**RE: Supplemental Groundwater Remedial Investigation Work Plan
Grand Union Hotel Bowling Alley Site
146 Westchester Avenue
Port Chester, New York 10573
NYSDEC BCP Site #C360222
SESI Project No. Project #11895A**

SESI has received the November 25, 2025 letter outlining the NYSDEC comments to the Supplemental Groundwater Remedial Investigation Work Plan (SGRIWP) for the Grand Union Hotel Bowling Alley Site. SESI has addressed the comments and documented our responses in red below.

FIG 3

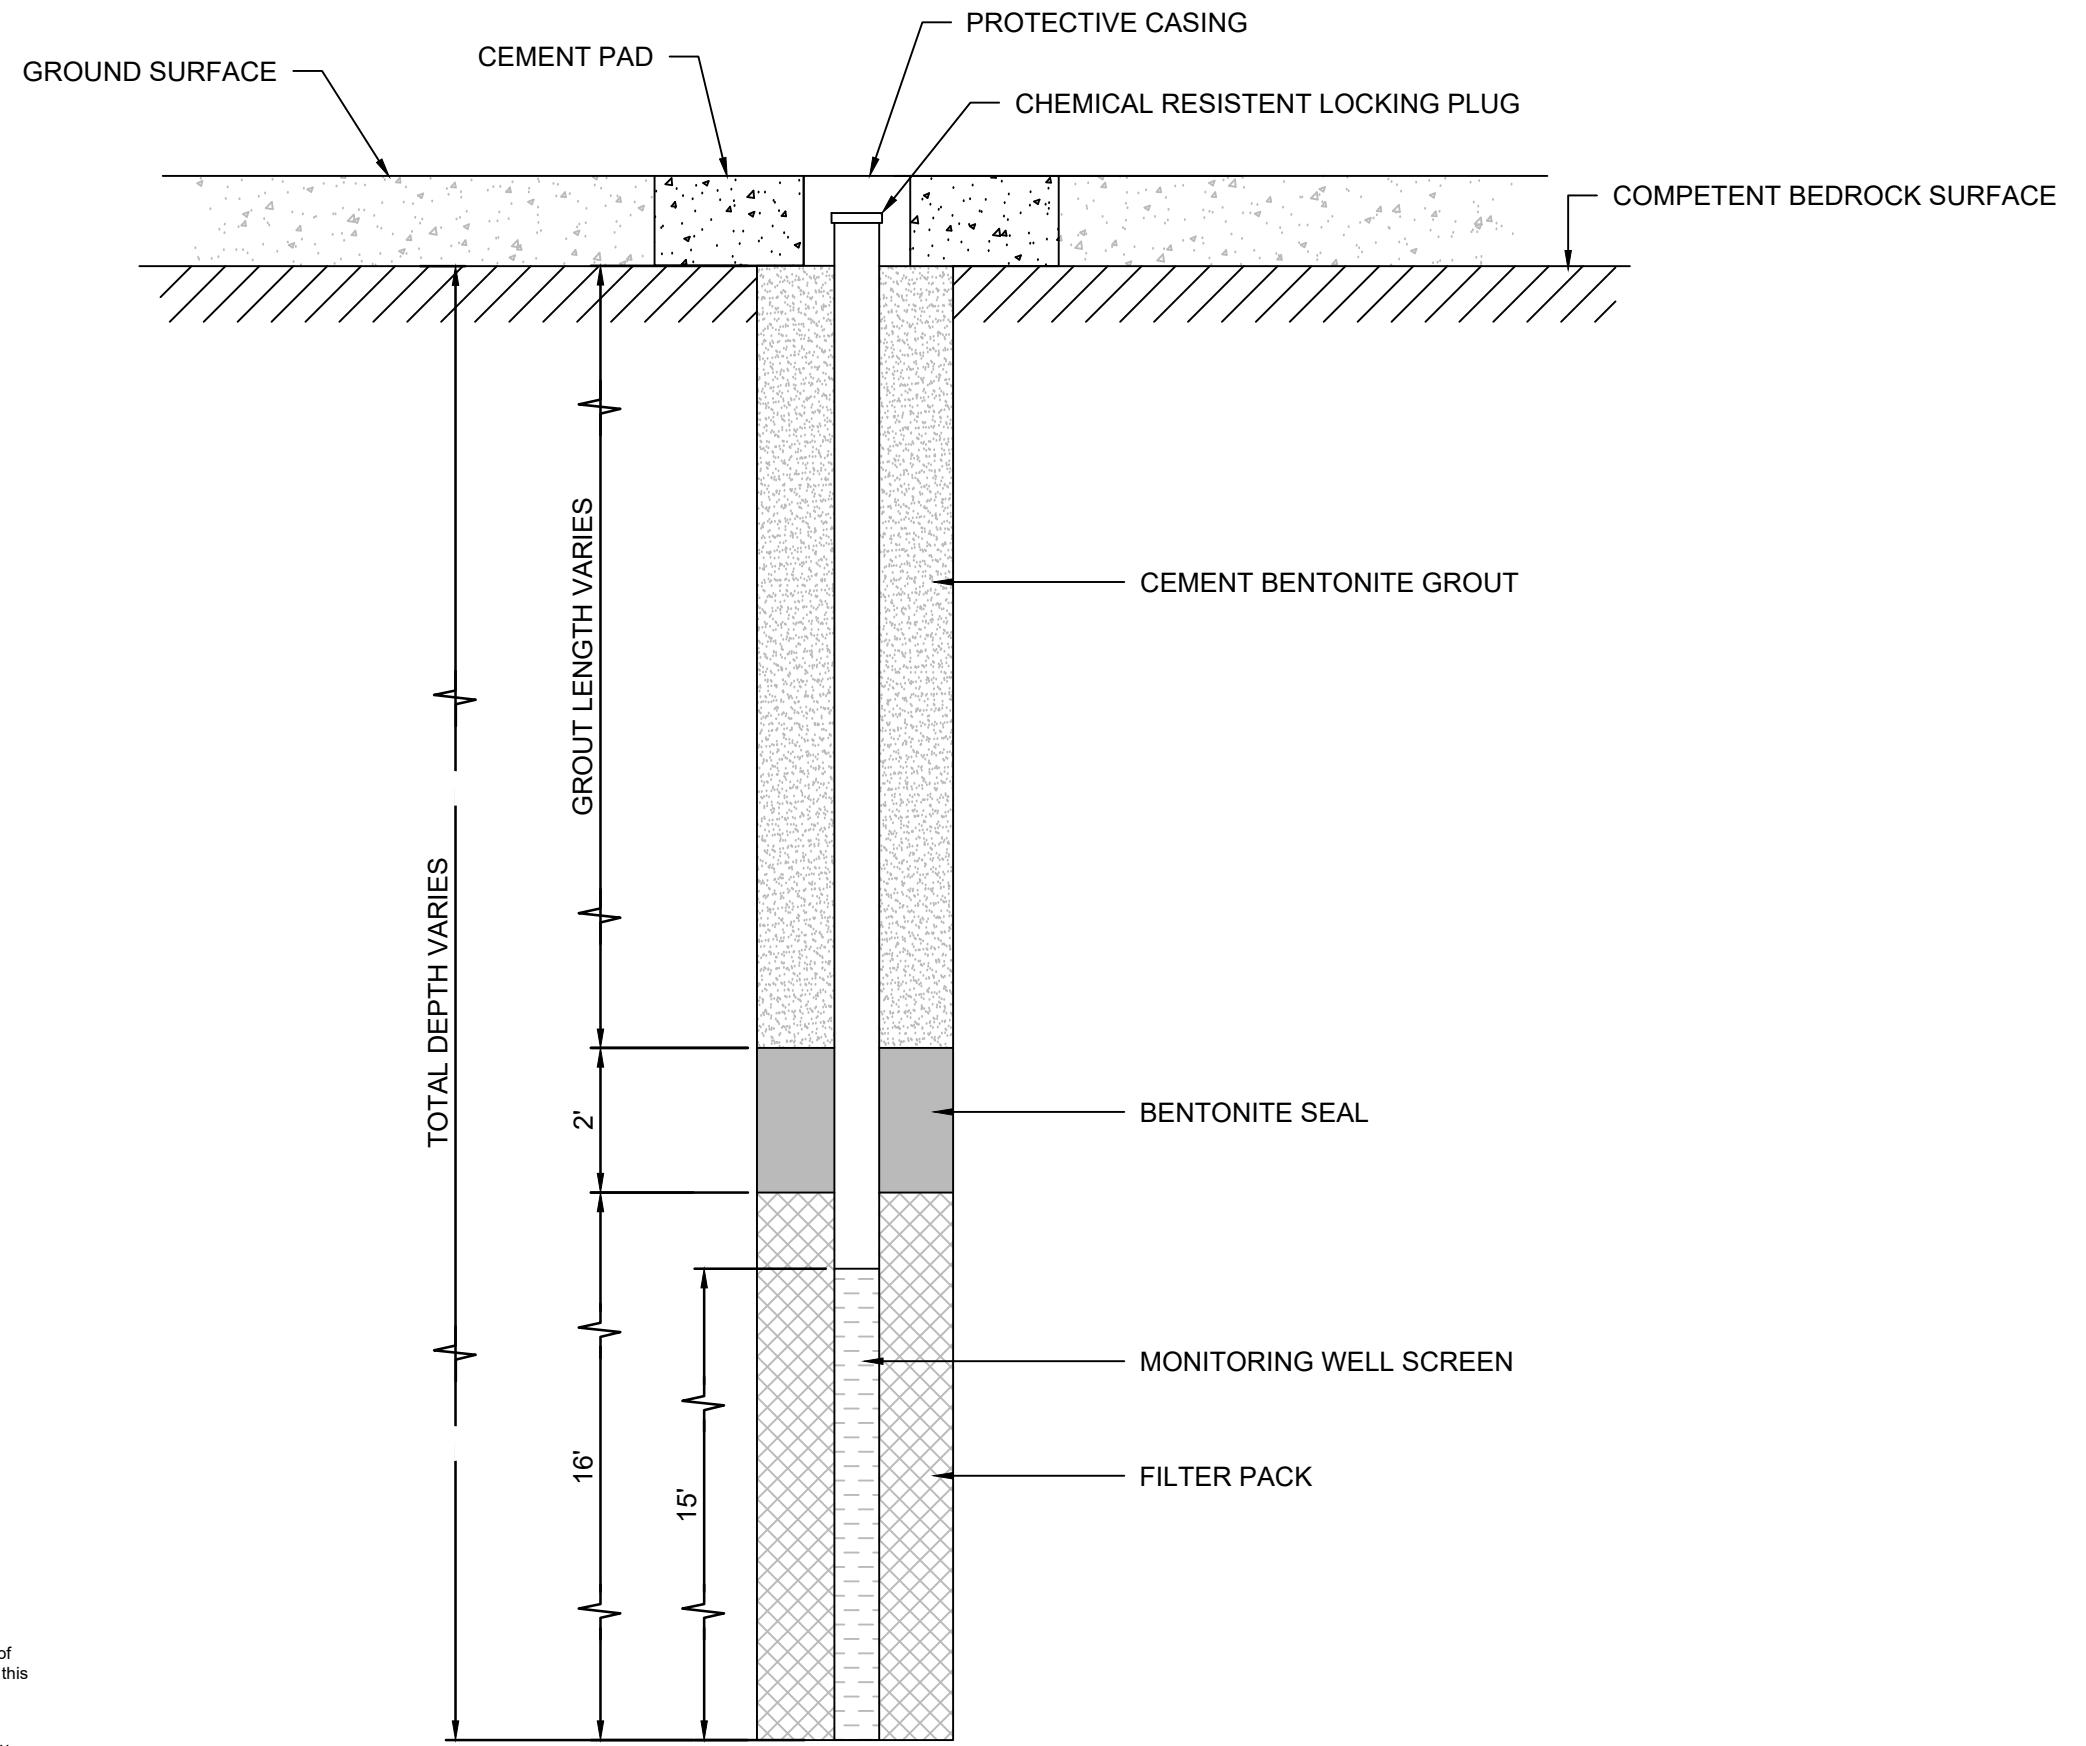
1. Table 1: borehole diameter should be of sufficient size to allow the passage of the tremie pipe to be used for well grout placement, as well as free passage of filter sands or bentonite pellets dropped through the auger or casing. In general, 4-1/4" inside diameter augers should be the minimum size used for placement of 2" nominal diameter casing.

Where neat cement grouts are to be used, the bentonite pellets should be hydrated for eight (8) hours, or the manufacturer's recommended hydration time, whichever is greater.

For this reason, monitoring wells should be double-cased to avoid cross-contamination between aquifers during installation.

Per discussions with the drillers, a 4-inch air hammer is the most proper for the field conditions and they confirmed that with this diameter they can fit the tremie pipe required for placing grout, filter sand, and bentonite pellets outside the of the well casing.

The SGRIWP is revised to specify double casing during monitoring well installation.
